INCH-POUND
MIL-PRF-19500/752A
w/AMENDMENT 2
15 June 2026
SUPERSEDING
MIL-PRF-19500/752A
w/AMENDMENT 1
22 August 2018

PERFORMANCE SPECIFICATION SHEET

* TRANSISTOR, FIELD EFFECT RADIATION HARDENED, N-CHANNEL, LOGIC-LEVEL SILICON, ENCAPSULATED (THROUGH HOLE AND SURFACE MOUNT PACKAGES), TYPE 2N7608, 2N7609 JANTXV, AND JANS

* FIGURE 1. Physical dimensions for TO-205AF (2N7608T2).

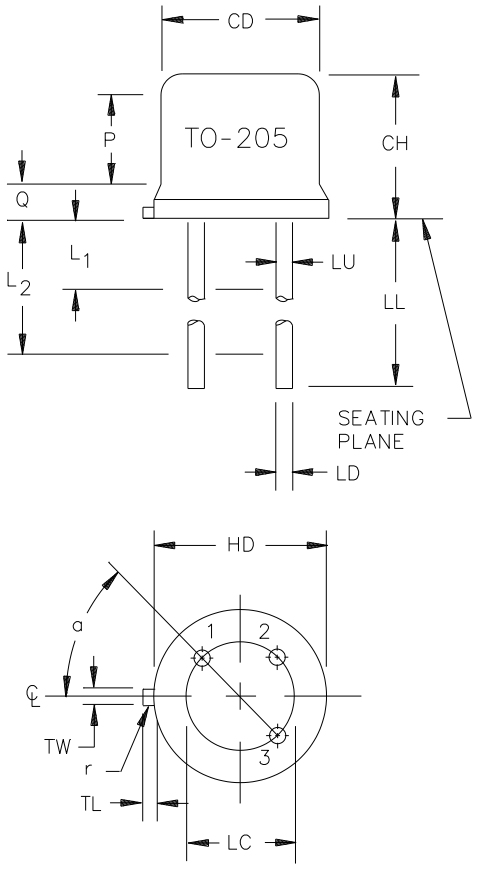
1. Dimensions are in inches. Millimeters are given for general information only.
2. Beyond radius (r) maximum, TW shall be held for a minimum length of .011 inch (0.28 mm).
3. Dimension TL measured from maximum HD.
4. Outline in this zone is not controlled.
5. Dimension CD shall not vary more than .010 inch (0.25 mm) in zone P. This zone is controlled for automatic handling.
6. Leads at gauge plane .054 +.001, -.000 inch (1.37 +0.03, -0.00 mm) below seating plane shall be within .007 inch (0.18 mm) radius of true position (TP) at maximum material condition (MMC) relative to tab at MMC.
7. LU applies between L_1 and L_2. LD applies between L_2 and LL minimum. Diameter is uncontrolled in L_1 and beyond LL minimum.
8. All three leads.
9. Radius (r) applies to both inside corners of tab.
10. Drain is electrically connected to the case.

* FIGURE 2. Dimensions and configuration (Similar to SMD-0.2), with ceramic lid (U8CE).

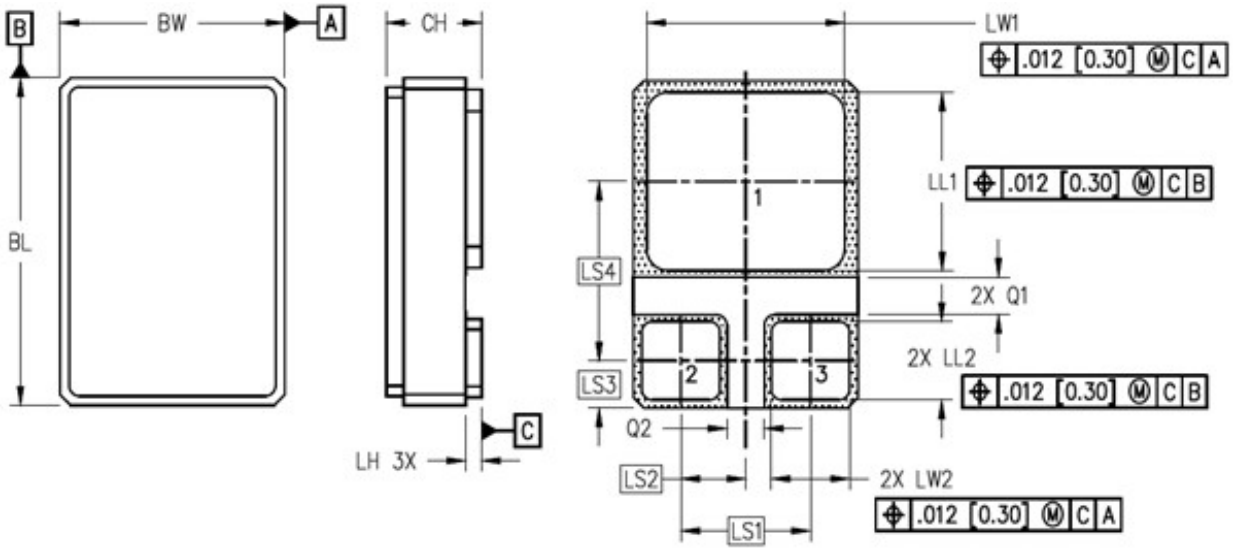
* 1.2 Package outlines. The device package outlines are as follows: TO-39 (TO-205AF) in accordance with figure 1 surface mount SMD-0.2, U8CE (ceramic lid) suffix in accordance with figure 2, for all encapsulated device types.

T2	Indicates the package is a TO-205AF (see figure 1).
U8CE	Indicates a ceramic lidded 3 pad surface mount package with enhanced PCB mount features, similar to a SMD-0.2 (see figure 2)

Symbol	Dimensions			
	Inches		Millimeters	
	Min	Max	Min	Max
BL	.300	.310	7.62	7.87
BW	.205	.215	5.21	5.46
CH		.097		2.46
LH	.010	.020	0.25	0.51
LW1	.180	.190	4.57	4.83
LW2	.068	.078	1.73	1.98
LL1	.161	.171	4.09	4.34
LL2	.068	.078	1.73	1.98
LS1	.121 BSC		3.07 BSC	
LS2	.061 BSC		1.55 BSC	
LS3	.044 BSC		1.12 BSC	
LS4	.167 BSC		4.24 BSC	
Q1	.030		0.76	
Q2	.030		0.76	
TERM 1	Drain			
TERM 2	Gate			
TERM 3	Source

NOTES:
1. Dimensions are in inches.
2. Millimeters are given for general information only.
3. Lid is isolated.
